Office Action Summary

10/726,605

SHANLEY, JOHN F.

DETAILED ACTION

FIG. 7A

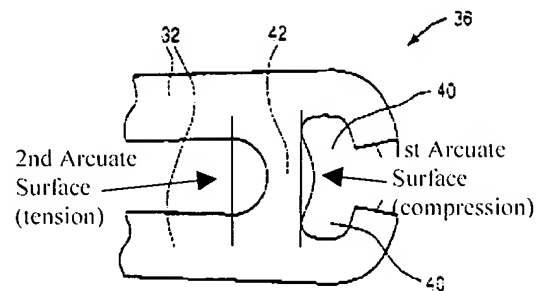
12. Klein discloses a stent with a plurality of beams (32), each beam defining a width, and plurality of ductile hinges (42), each hinge defining a width, thickness and length.

The hinge width is smaller than the beam width such that the hinge experiences plastic deformation when the device is expanded from a first to a second diameter. The hinges are in the shape of curved beams along their lengths having first and second arcuate surfaces with the second surface longer than the first. Referring to the marked up version below, the lines indicate the endpoints of each arc, which indicate the starting and ending points for measuring the surface of the arcs. It should be clear that the longer arcuate surface is the concave surface on the left side of the drawing. The curved beams are located so that during expansion of the device, tensile strain is distributed along the second arcuate surface as depicted below. Because the longer second arc will be in tension during expansion of the stent and will be in compression during compression of the stent, the percentage of expansion to reach the predetermined strain level will be more than the percentage of compression to reach the same strain level. The hinge width is at least 50% or $\frac{2}{3}$ smaller than the beam width (Fig. 7A). There is an abrupt transition between the cross sectional area of the beams orthogonal to the beam length and the cross sectional area of the ductile hinges orthogonal to the hinge length that extends less than 10% of the length of the beam. The ratio of the length of the hinge to the length of the beam is less than 1:6. The ductile hinges are asymmetrical (Fig. 7a where the line of asymmetry goes from the top

of the figure to the bottom). The ductile hinges are configured so that upon compression during crimping, the strain will be distributed along the first arcuate surface and upon expansion, the strain will be distributed along the second arcuate surface (see below).

32. Applicant's arguments filed 04/24/06 have been fully considered but they are not persuasive. Applicant states that one of the differences between the device of the instant invention and the prior art of Klein is the orientation of the hinges and the stress-strain experience during expansion of the device. The rejection has been improved to clarify the examiners position. It should be clear that the longer arcuate surface is in fact

in tension when the stent is expanded as depicted in the instant claims and further clarified in the remarks.
